Recorded Owner/ Applicant	:	Howard Demello
Agent	:	Kathleen M. Douglas
Location	:	54-002 Haukoi Place, Hauula, Oahu
Tax Map Key	:	5-4-12: 16
Request	:	Shoreline Setback Variance
Proposal	:	Repairs to Existing Sea Wall
Determination	:	<u>A Negative Declaration Is Issued</u>

FINAL ENVIRONMENTAL ASSESSMENT

SUBJECT: ENVIRONMENTAL ASSESSMENT - REPAIRS TO EXISTING SEAWALL
54-002 HAUKOI PLACE, HAUULA, OAHU
TAX MAP KEY 5-4-12: 16
PROJ. REF. NO. 92/SV-013(ASK)

SUBJECT: Draft Environmental Assessment (DEA) for a Shoreline Variance
(92/SV-013): Sea Wall Repairs at 54-002 Haukoi Place, Hauula,
Oahu, TMK: 5-4-12: 16

EXHIBIT "D"

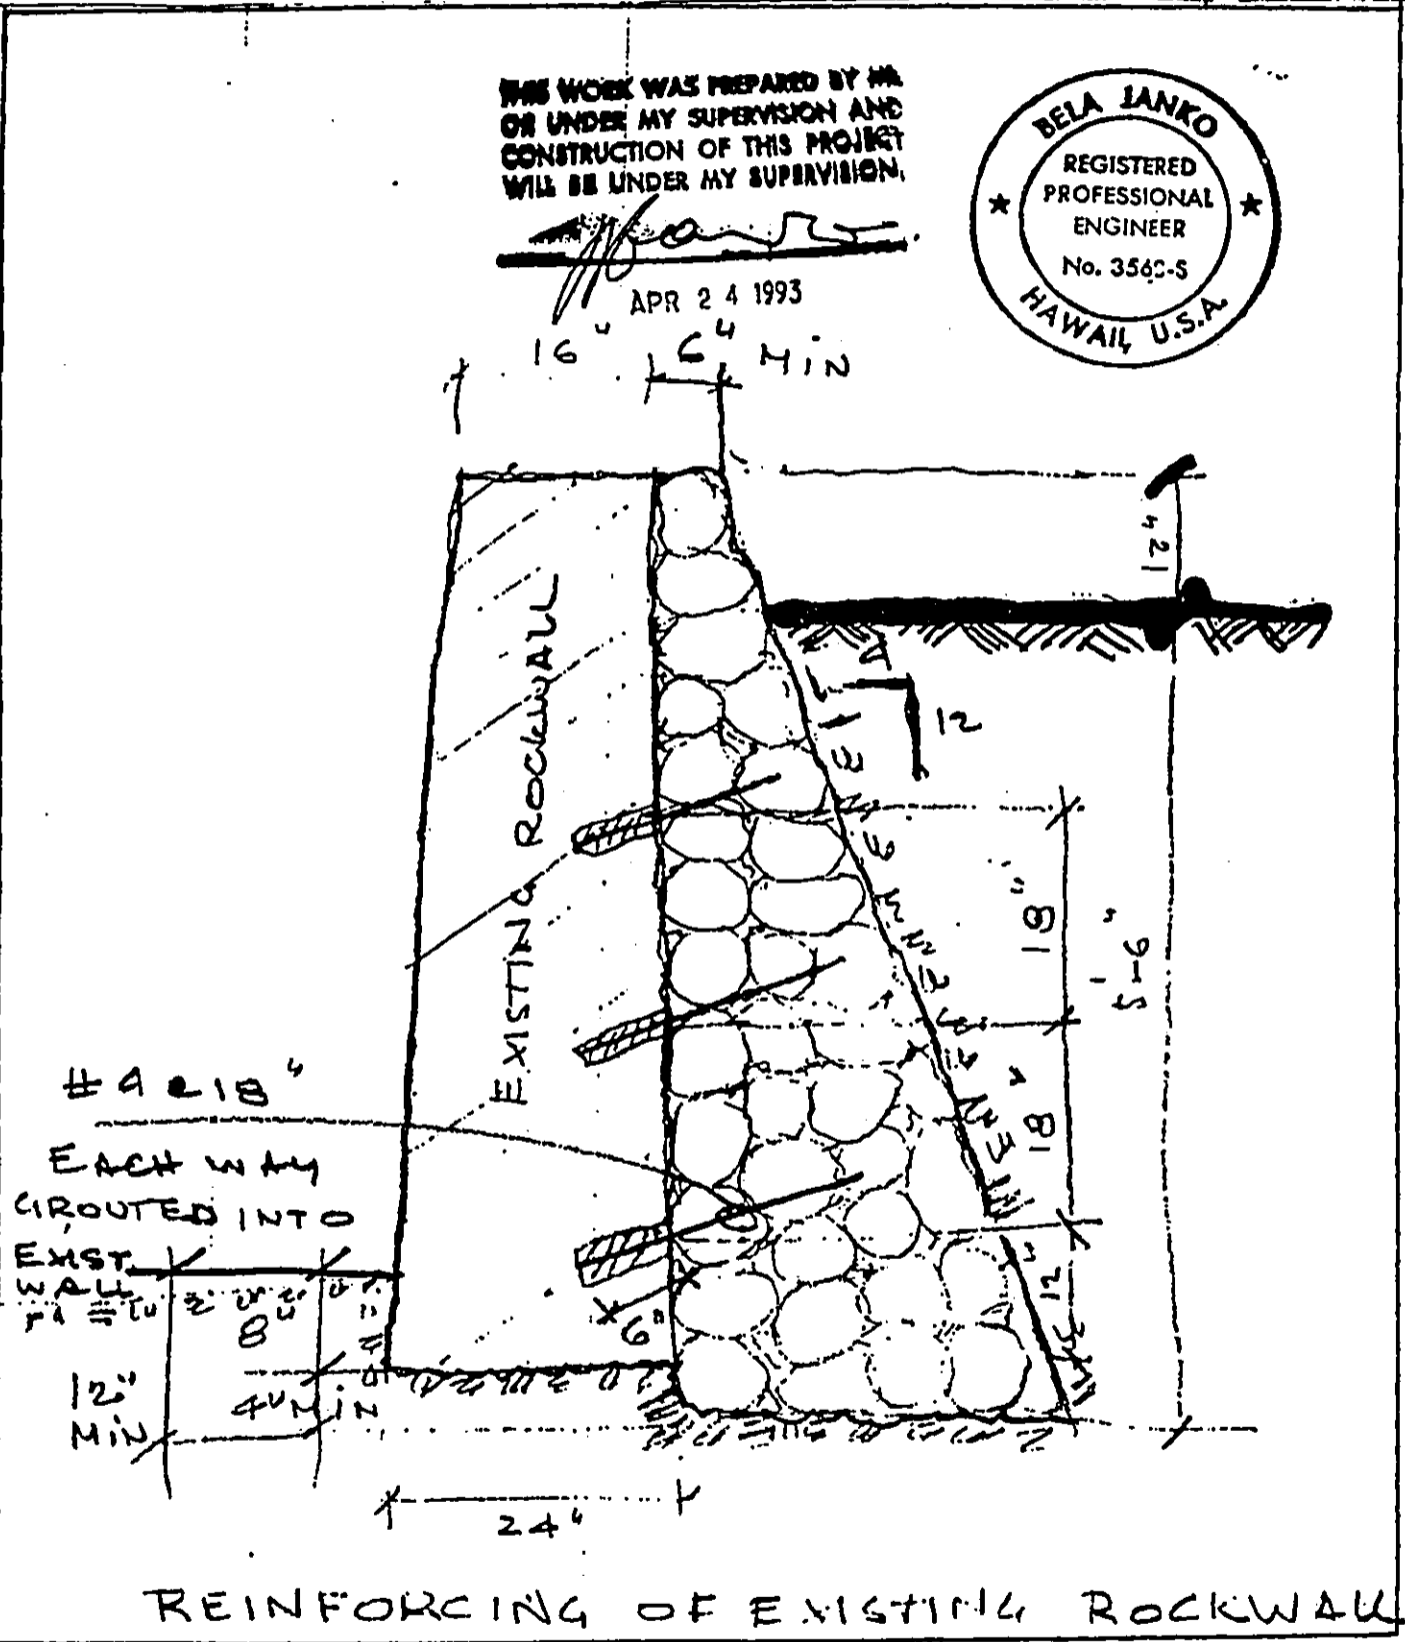
The Division of Boating and Ocean Recreation comments that they have no
objections provided that the toe of the new construction of the seawall
repairs is above the upper reaches of "normal" wave patterns, and that
public pedestrian access along the shoreline is not obstructed.

The environmental assessment states that: "There is no room for a sloping rock revetment, and it would not match the character of the surrounding shore protection." The document does not discuss specific dimensions that would prohibit the construction of a sloping rock revetment. A more appropriate shore protection strategy for the subject property would be the employment of a revetment versus a vertical seawall.

Regarding Division of Boating and Ocean Recreation comments:
The toe of the new construction of the seawall repairs will
be above the upper reaches of "normal" wave patterns, and public
pedestrian access along the shoreline will not be obstructed.
